Development Address: 7449 Frankstown Ave

Project Description: combine two buildings to create a 15 unit multi-family building

DCP-ZDR-2020-00675

Site Plan Review Comments -- The following items must be addressed in order for the Site Plan Review to proceed. Please email revisions to the application package based on these comments to me (daniel.schepke@pittsburghpa.gov). I will verify that the revisions are consistent with the comments and contact you with any questions. In the meantime, if you have any questions about the comments or the review process, please let me know so that we may discuss.

1 PROPOSED SITE PLAN
 Scale: 3/16"=1'-0"

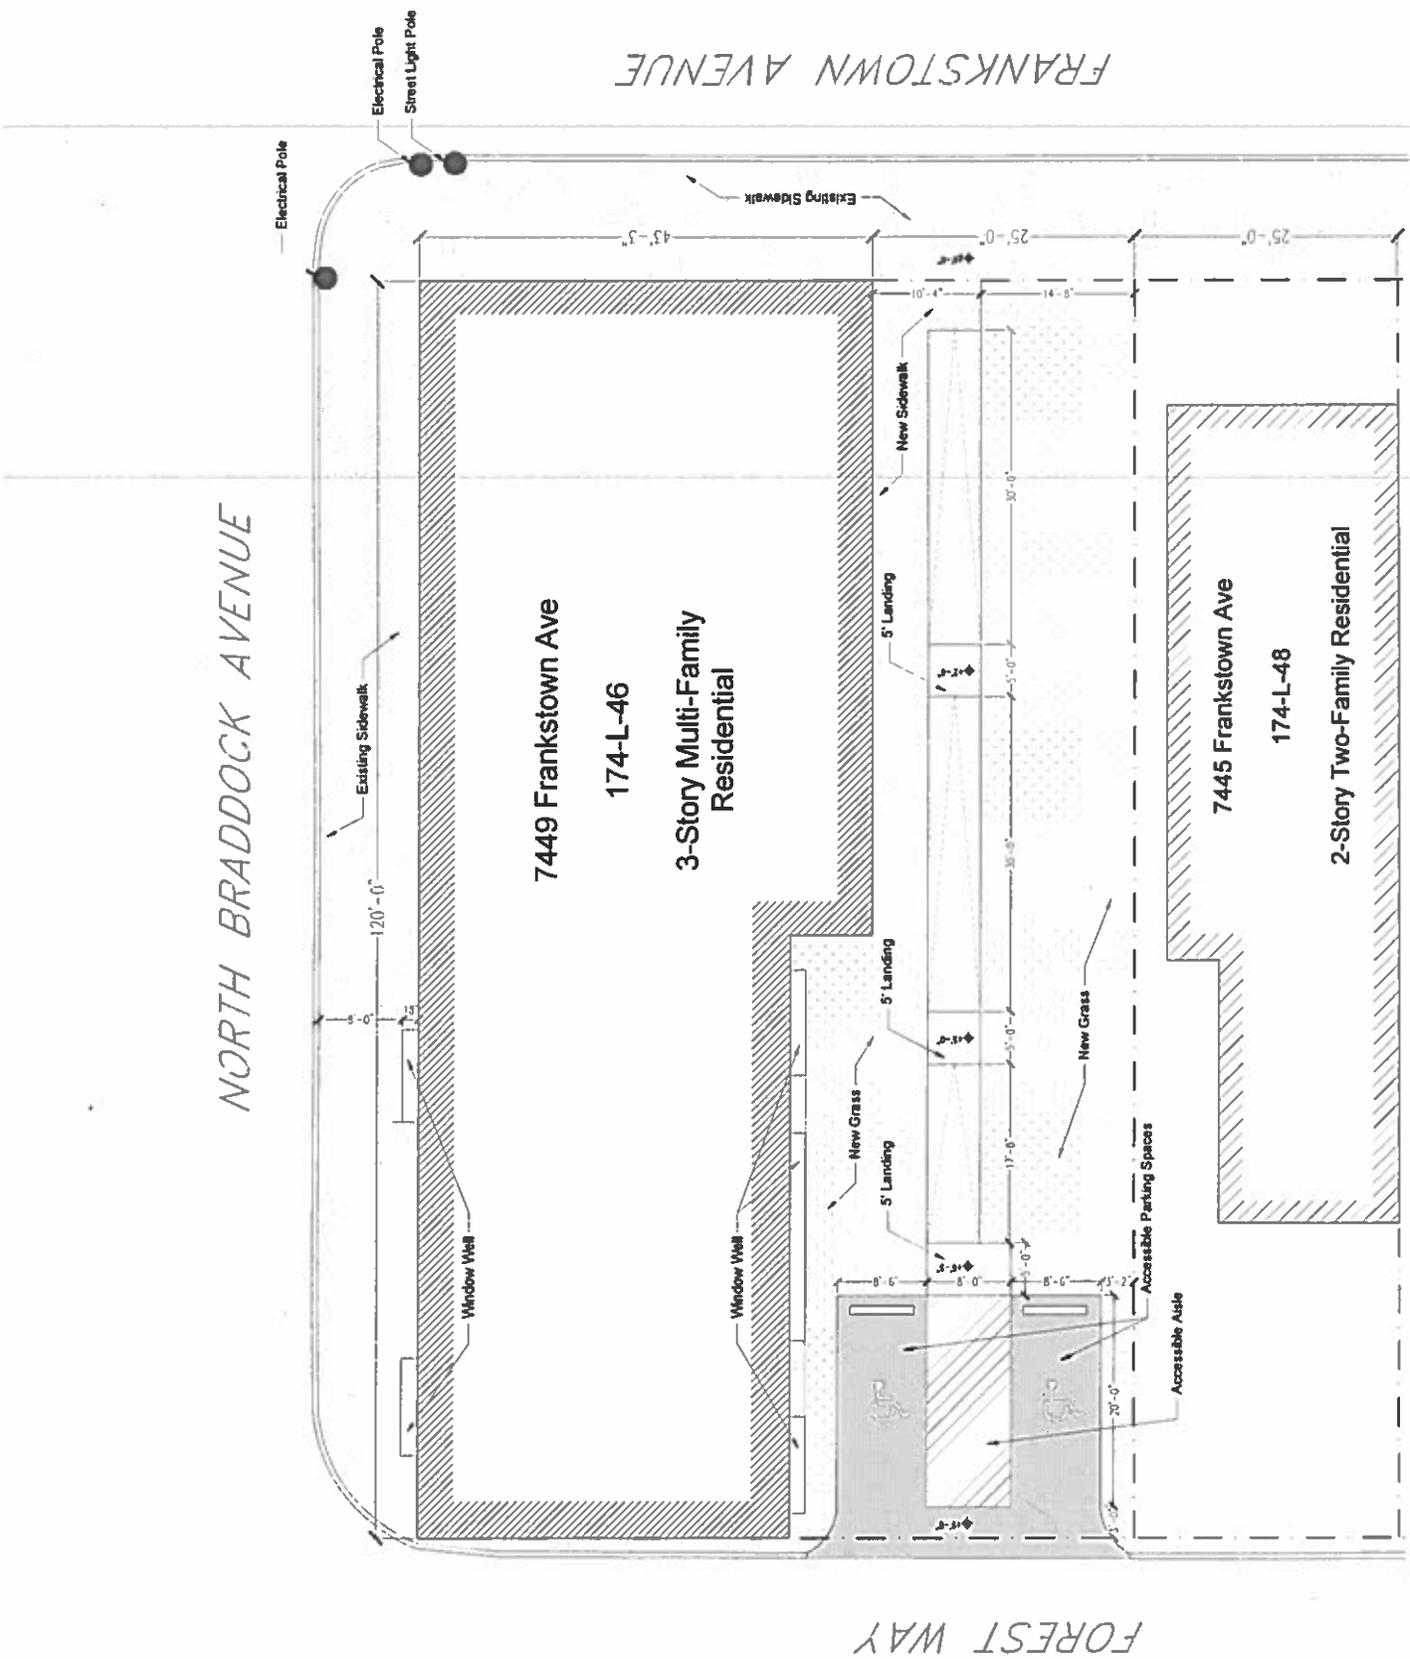
3. A Zoning Board of Adjustment (ZBA) Hearing is required for the project. The parking is located in the 15' residential compatibility setback. Residential Compatibility standards can be waived by the ZBA as a Special Exception. Lana Ipatova will follow up with the confirmed date and hearing time when the required 21 day notice poster is ready. The fee for a ZBA hearing is \$550.00, which is due when the poster is picked up from the Zoning Counter.

5. The apartments need to have at least one protected bike space. Protected Bicycle Parking Spaces are secure facilities which protect the entire bicycle, its components and accessories against theft and against inclement weather. Show the 4' x 6' bike parking footprint on site plan. Bike parking spaces also need a 4' minimum access aisle in addition to the 4' x 6' bike parking footprint. Provide a detail of the proposed bicycle rack and information about how it will be protected.
6. On the revised site plan, show the distance from the edge of the parking area to the building. The space needs to be at least 3' from the building.

7. A total of 6 street trees are required for the site's frontage on North Braddock Ave and Frankstown Avenue. On a landscape plan, show the 30 SF (ideally 3' x 10') planting pits and location of the street trees. Indicate the tree species for the proposed street trees and provide a planting detail. Work with Lisa Ceoffe (412-670-5072, lisa.ceoffe@pittsburghpa.gov) on the selection and placement of street trees.
8. Provide information about how residents of the apartment building will manage trash. If there is going to be a dumpster or a place where everyone brings their trash for pick-up, that area will need to be screened on all sides in accordance with 918.02.

11. A Curb Cut permit is needed for the new driveway access proposed off Forest Way. Email Bobbie Abbondanza (bobbie.abbondanza@pittsburghpa.gov) to schedule a time to apply for the curb cut permit at DOMI's permit office at 611 Second Avenue. Please provide the Zoning application number – DCP-ZDR-2020-00675 – along with DOMI's required application drawings. the Curb Cut permit must be issued to obtain final Zoning approval.
